Access Compliance Report Public Rights-of-Way (Curb Ramps)

Main Street: HYDRANGEA_ST Cross Street: SMOKE_TREE_DR Location: NE

ADA ID: RPAT211102151614 Ramp Type: Type 1 - Perpendicular Diagonal Initial Pass/Fail: Fail Overall Compliance: No Severity Score: 30

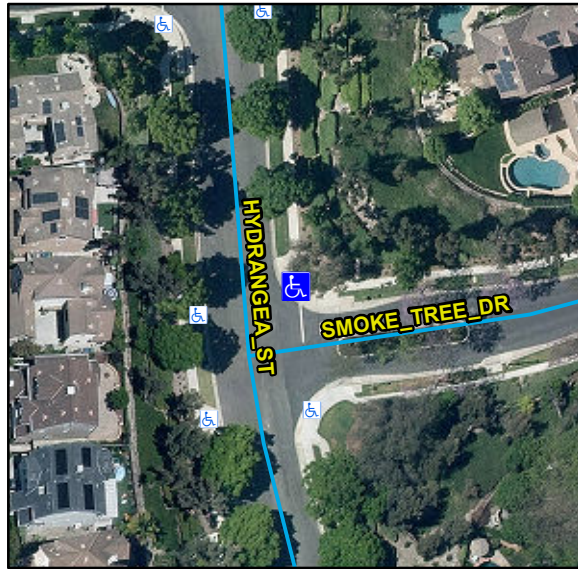
Compliance	Description	Data	Compliance	Description	Data
N/A	Ramp Length (in)	90	N/A	Flare Type LT	
Yes	Ramp Width (in)	48			N/A
Yes	Ramp Run Slope (%)	7	N/A	Flare Slope LT (%)	N/A
No	Ramp Cross Slope (%)	9.8	N/A	Flare Traversable LT	N/A
N/A	Landing Present	N/A	N/A	Flare Type RT	
N/A	Landing Length (in)	N/A			N/A
N/A	Landing Width (in)	N/A	N/A	Flare Slope RT (%)	N/A
N/A	Landing Run Slope (%)	N/A	N/A	Flare Traversable RT	N/A
N/A	Landing Cross Slope (%)	N/A	N/A	DWS Provided	N/A
N/A	Landing Movement Obstructed?	N/A	N/A	DWS Contrast	N/A
	Landing Movement Type	N/A	N/A	DWS Length (in)	N/A
N/A	Landing Shared	N/A	N/A	DWS Full Width	N/A
N/A	Clear Space	Yes	N/A	DWS Offset Left (in)	N/A
N/A	Clear Space To Crosswalk (in)	N/A	N/A	DWS Offset Right (in)	N/A
N/A	Marked Crosswalk 1	No	N/A	Marked Crosswalk 2	No
	Crossing 1 Direction	W		Crossing 2 Direction	S
	Marked Crosswalk 1 Width (in)	N/A		Marked Crosswalk 2 Width (in)	N/A

Remove & Replace Curb Ramp With Two New Directional Ramps or Equivalent.
